Date: November 30, 2023
To: All Vendors
Subject: Addendum #2

**REFERENCE: B014-24 Re-Bid BPUB Downtown Wastewater Improvements-ARPA
Project 1**

Project:	Brownsville PUB – Downtown Wastewater Improvements ARPA Project 1 BPUB Bid No. B014-24	Addendum Date:	November 30, 2023
From:	Javier A. Esquivel, PE	Project No.:	BPUB2200025.01

ADDENDUM No. 2

SHEET
 CA02

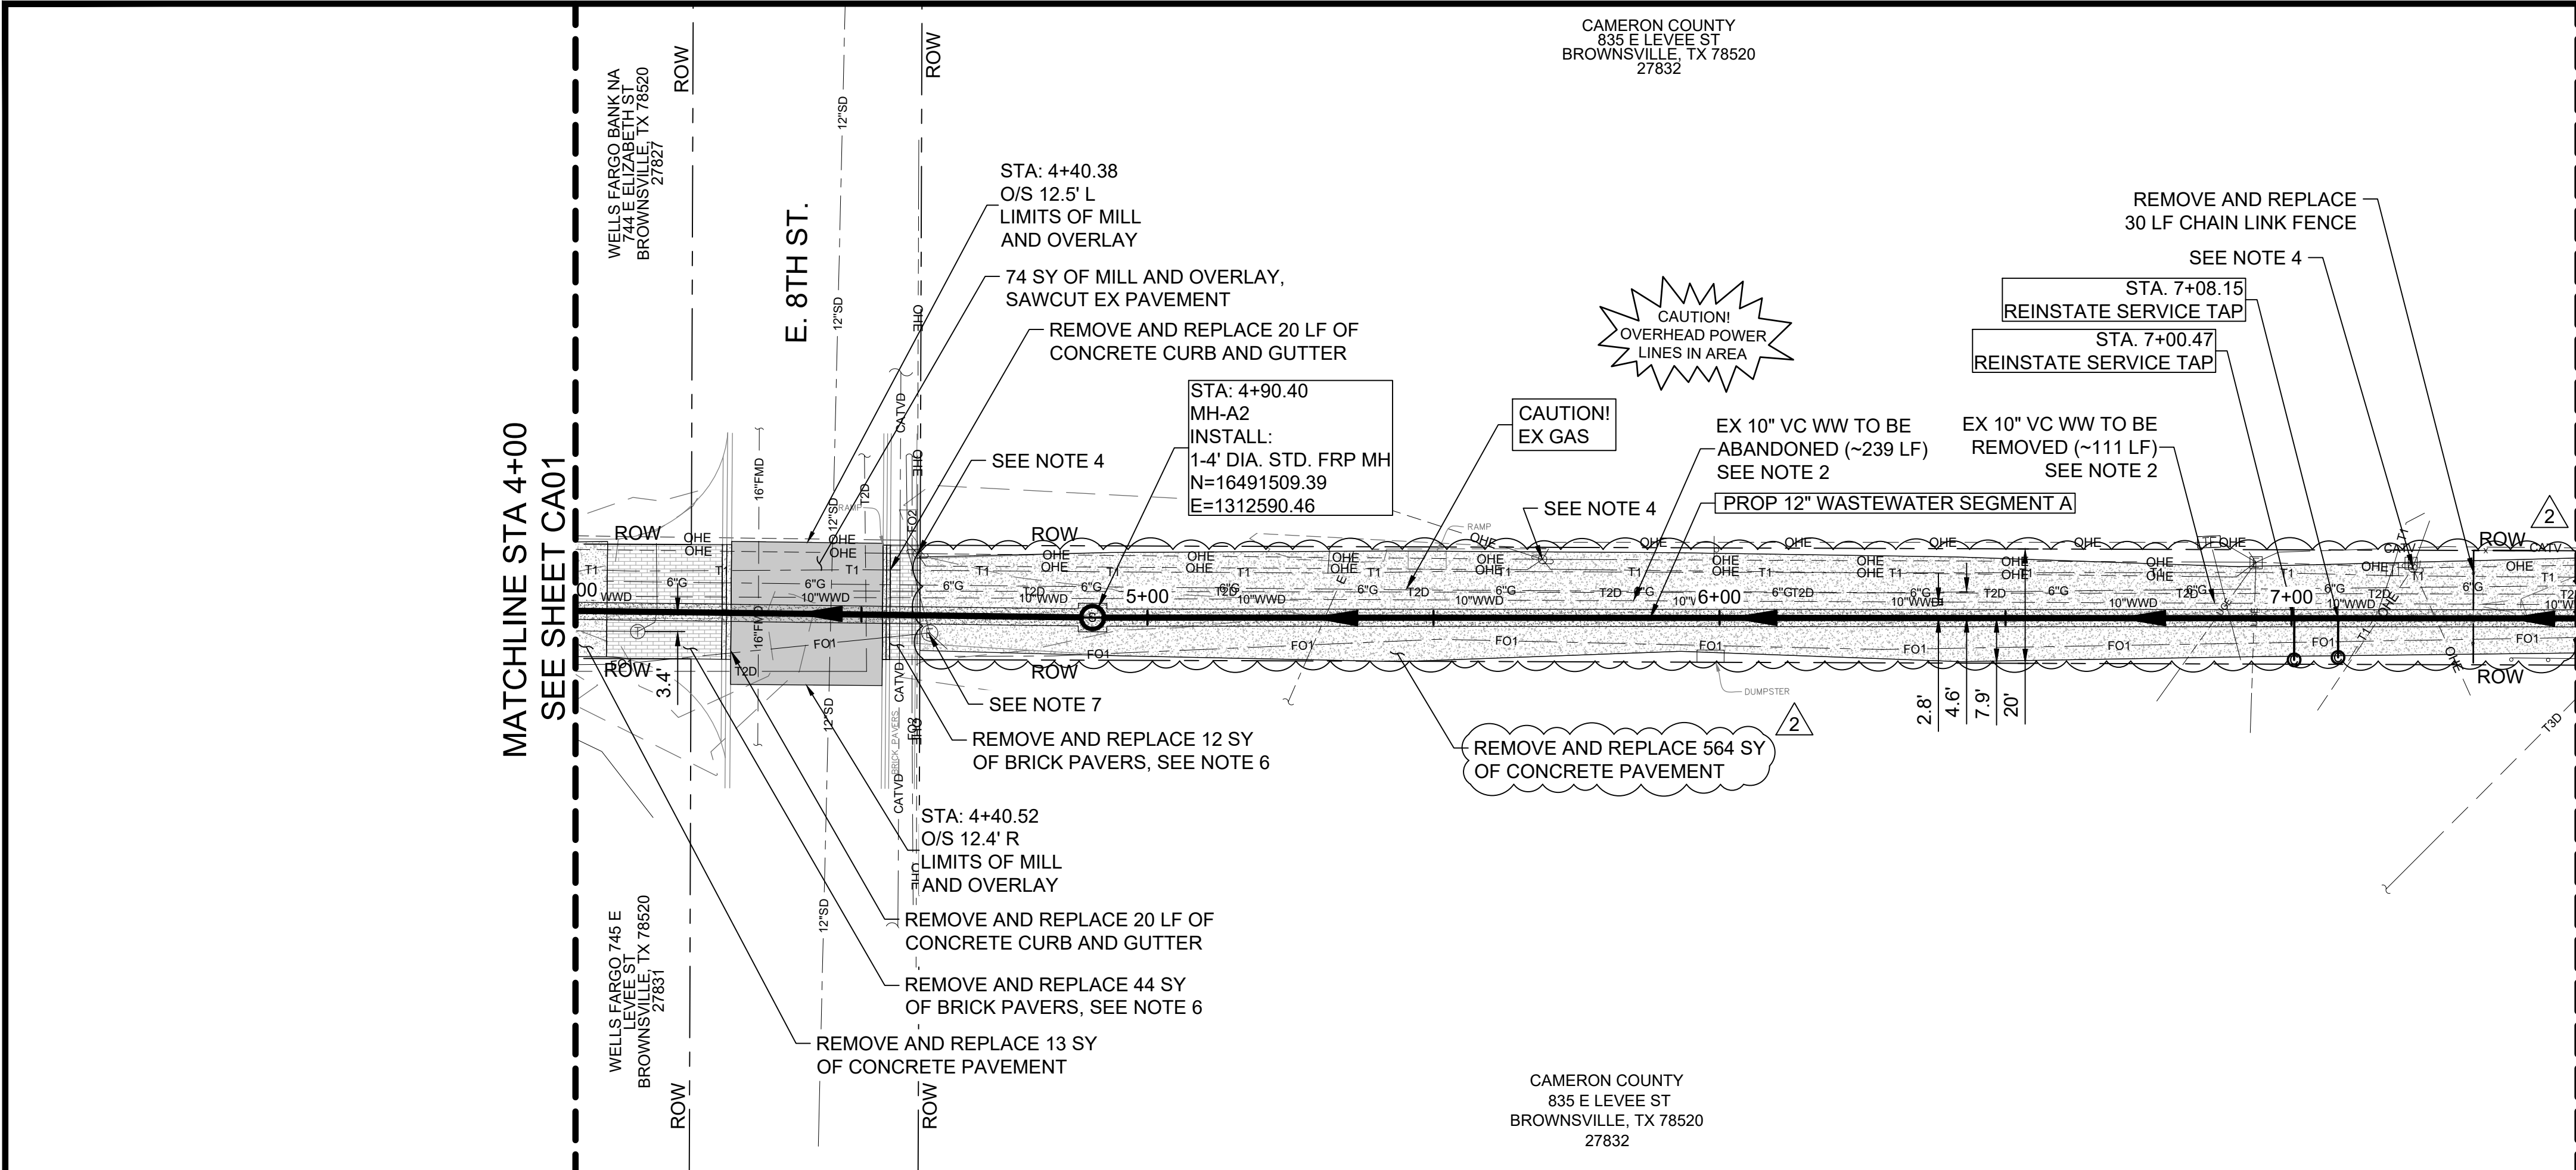
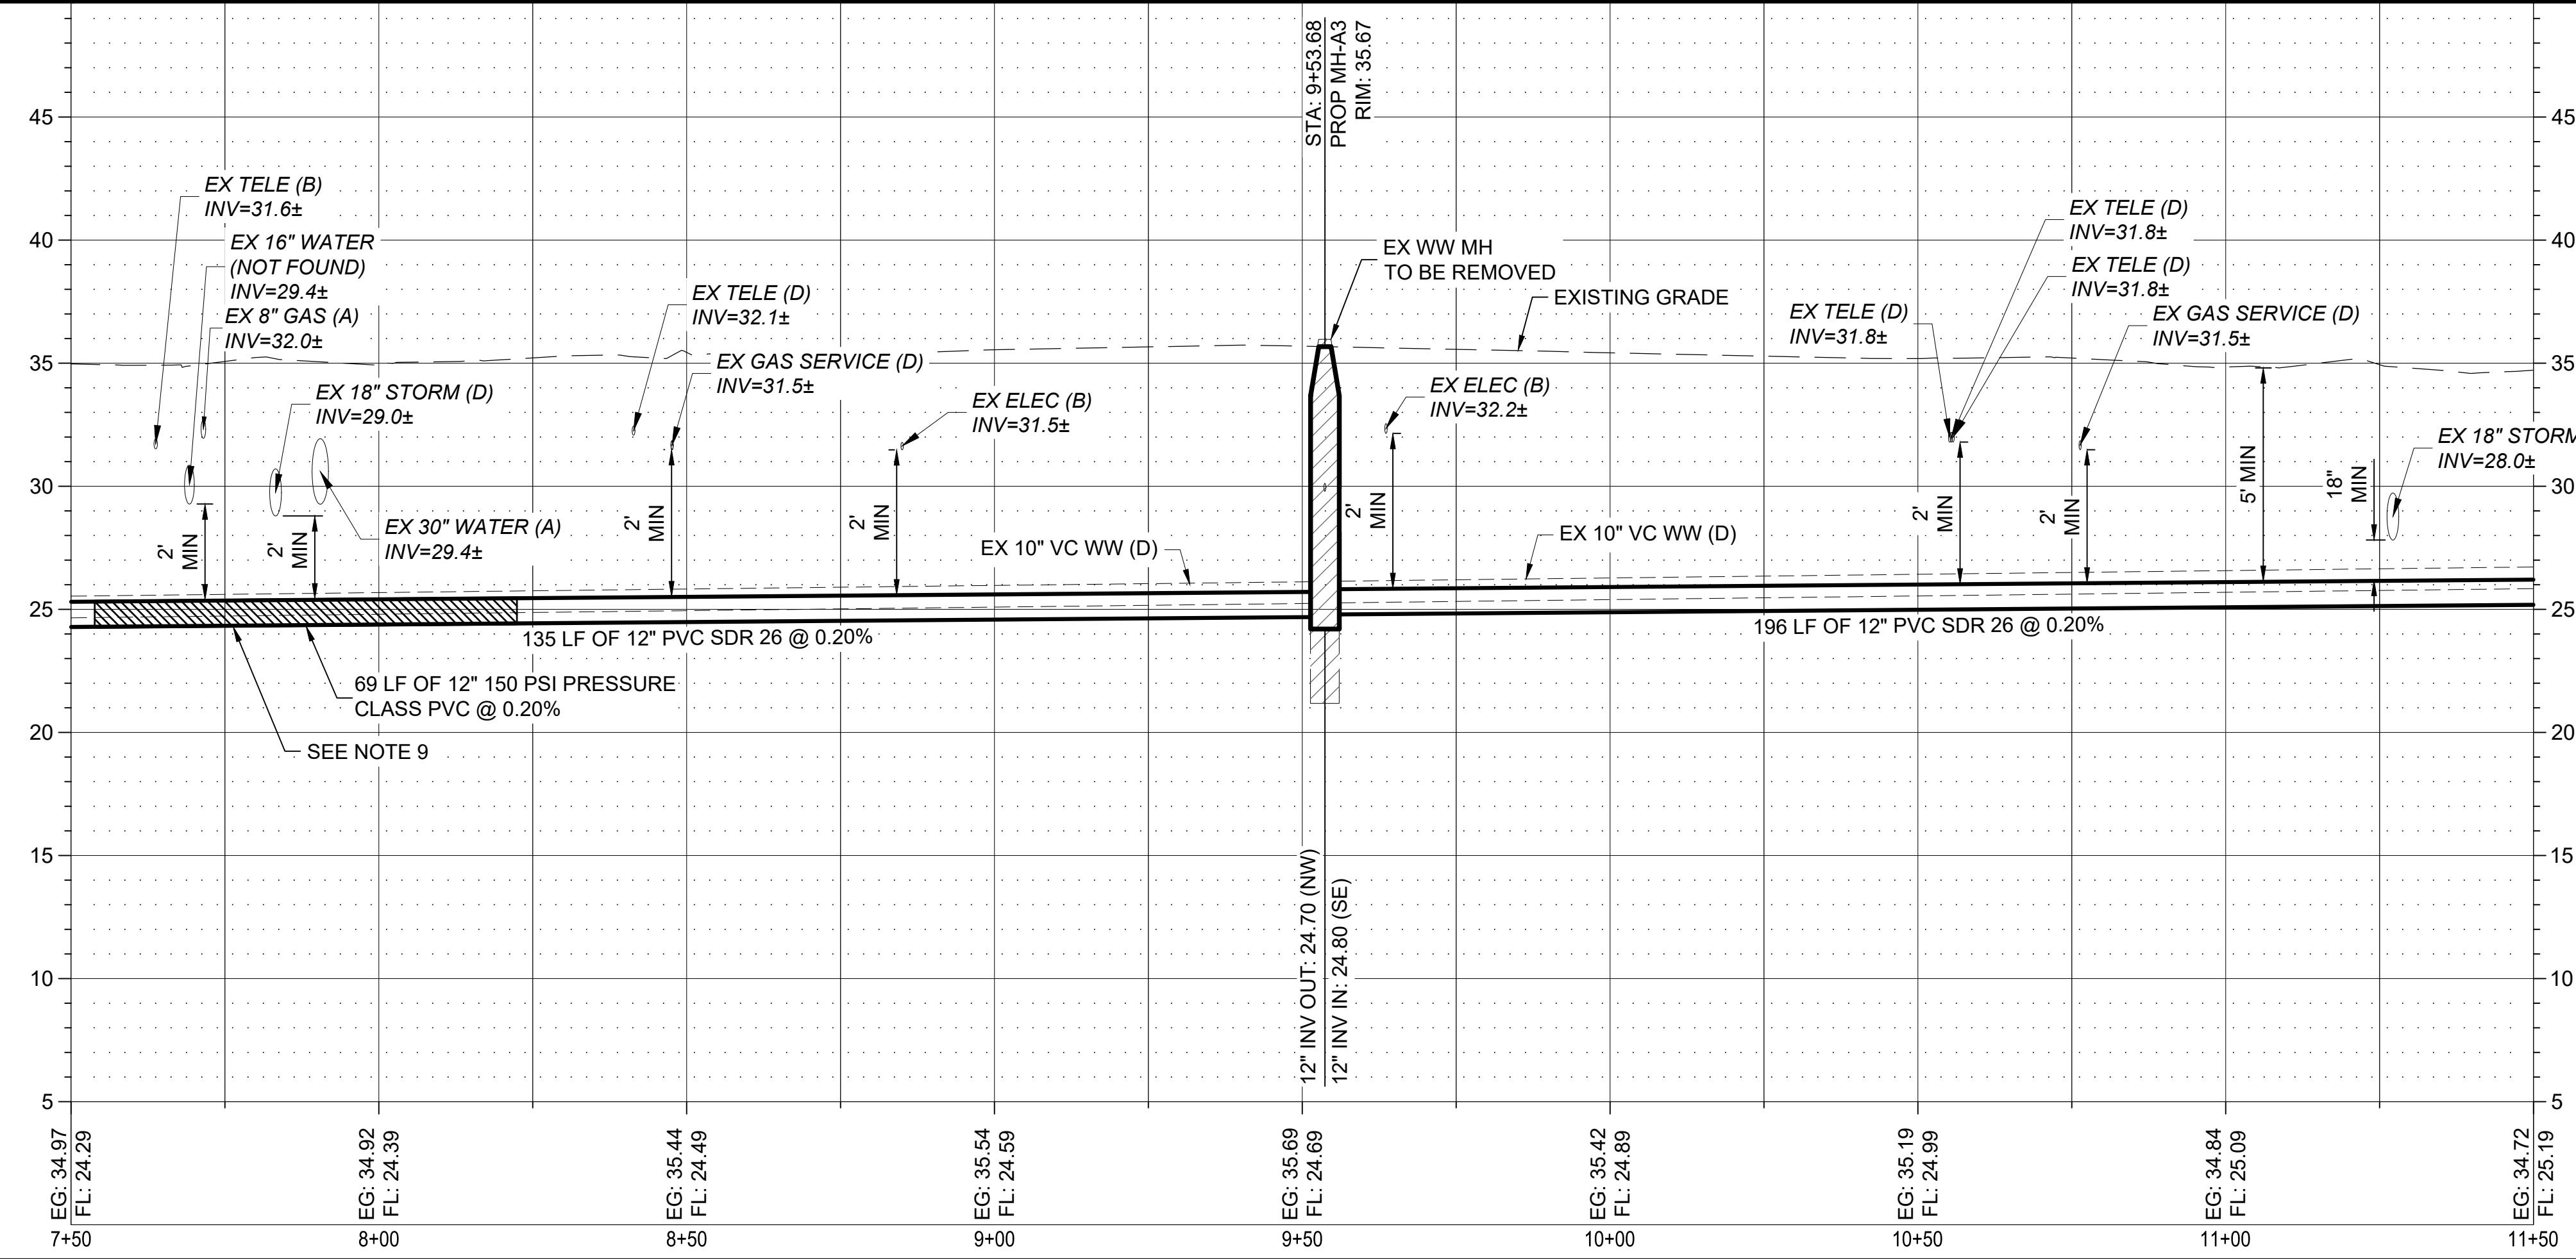
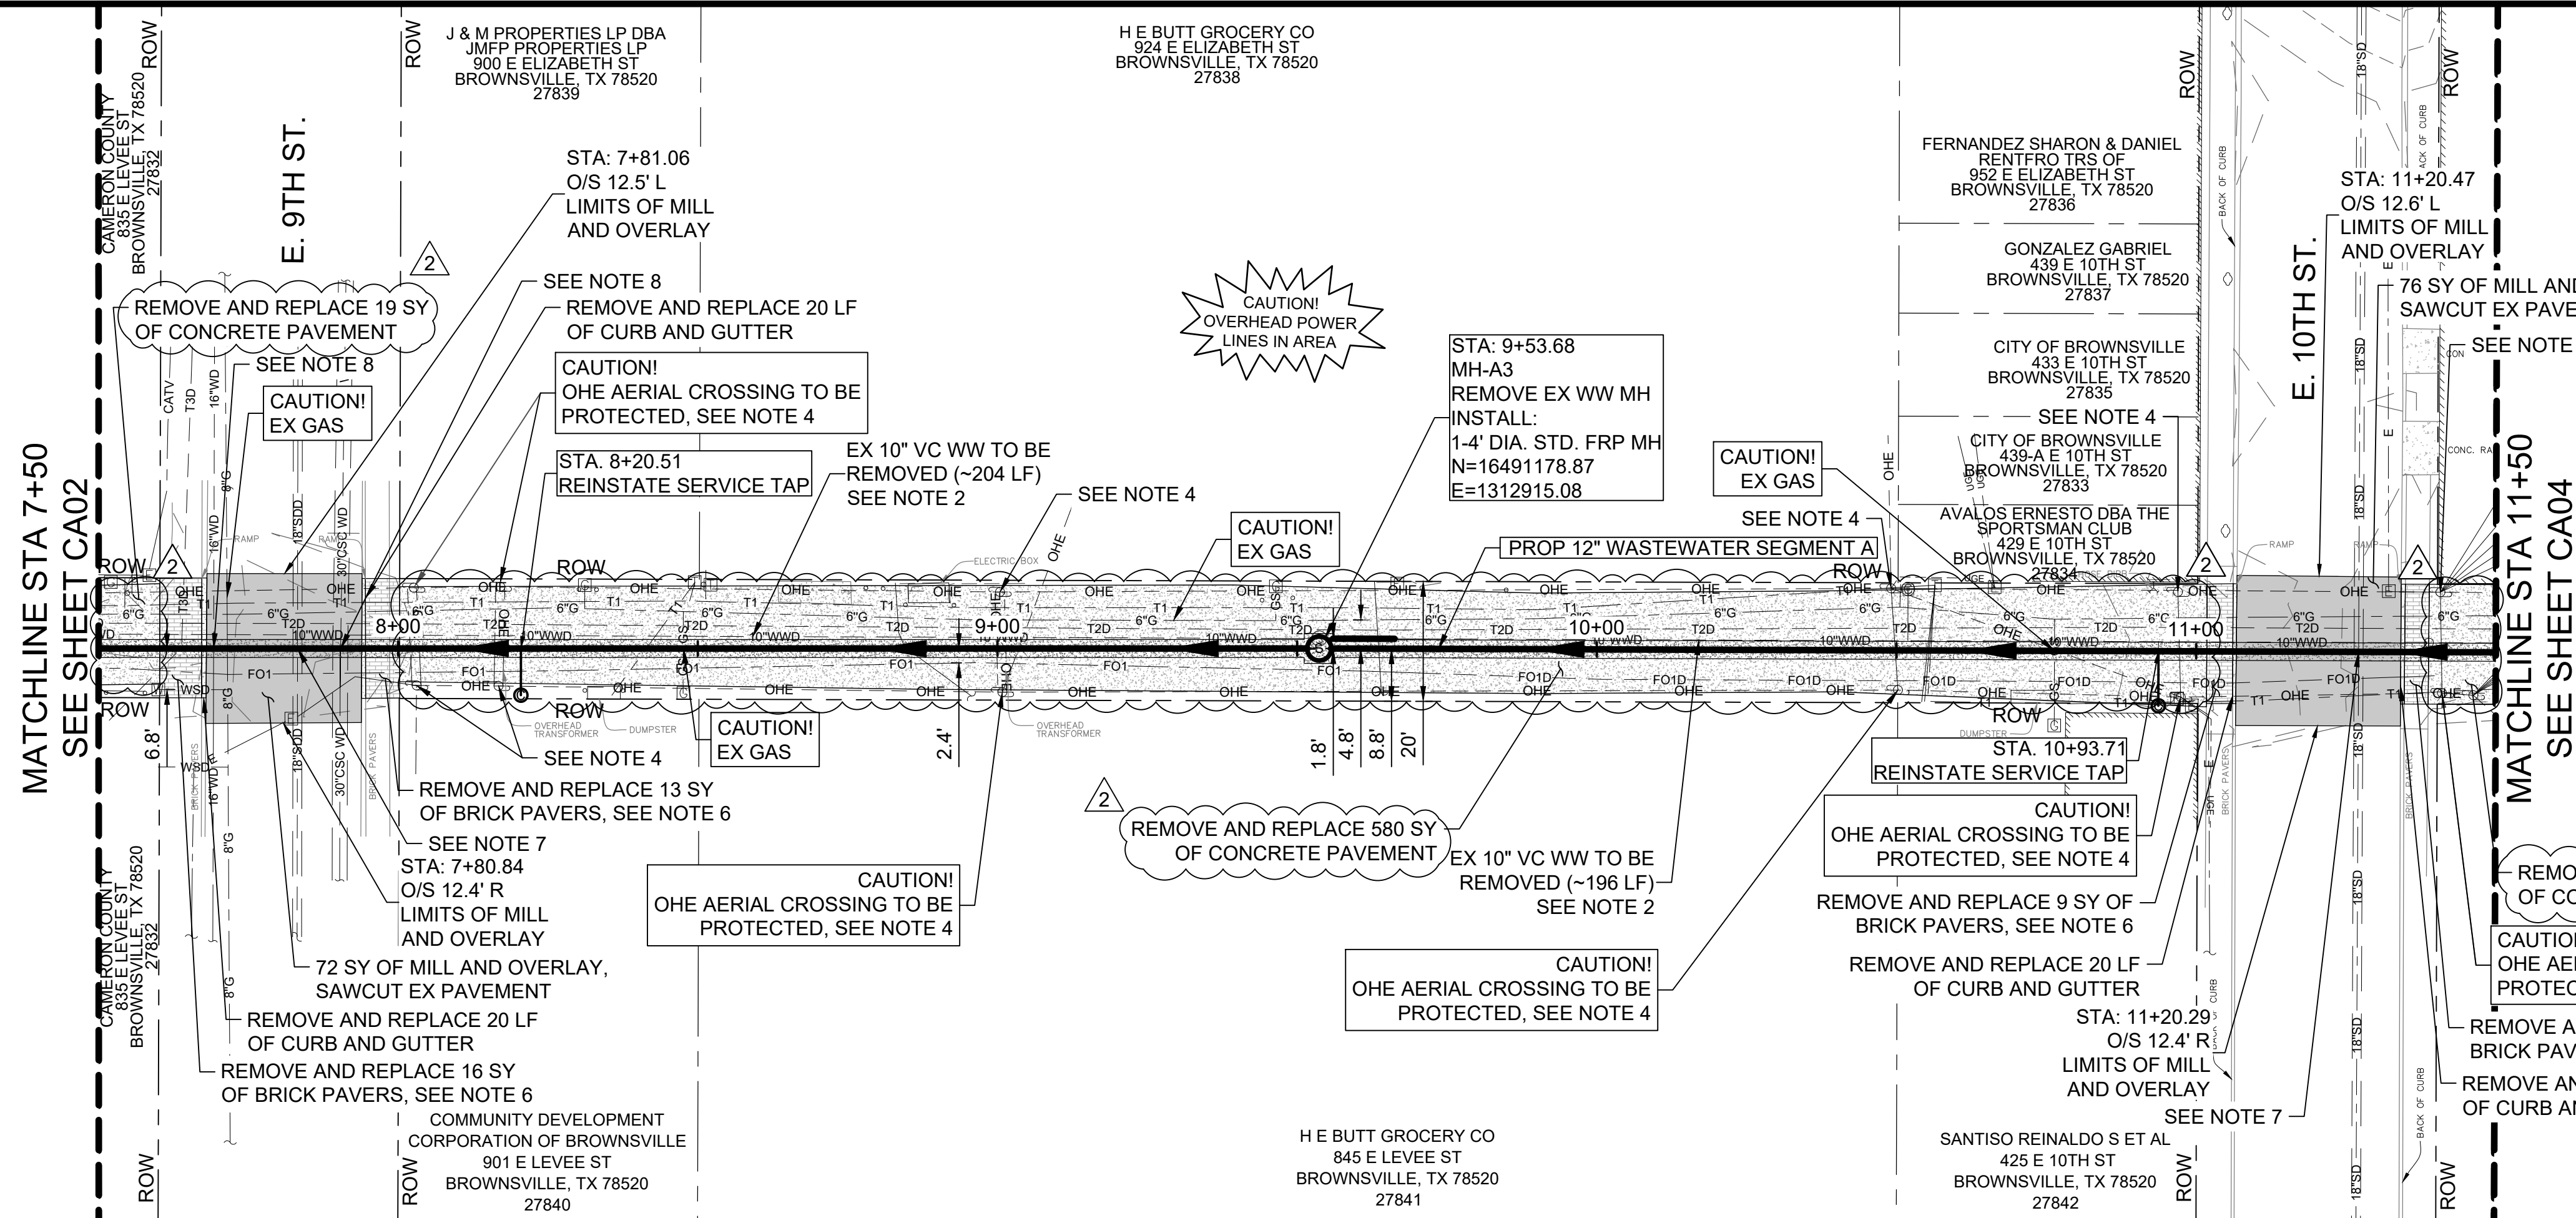
1. Revisions to Surface Restoration in the Alleys.
 - Segment A: Replace Mill and Overlay (2”) with full depth concrete asphalt pavement removal and replacement.
 - Segment B: Replace Mill and Overlay (2”) with full depth asphalt pavement removal and replacement.
 - Segment C: Replace Mill and Overlay (2”) with full depth asphalt pavement removal and replacement.

3. Plan Sheets: The following plan sheets were modified to update surface restorations CA02, CA03, CA04, CA05, CA06, CA07, CB01, CB02, CB03, CC02, CC03, CC04, and CC05.
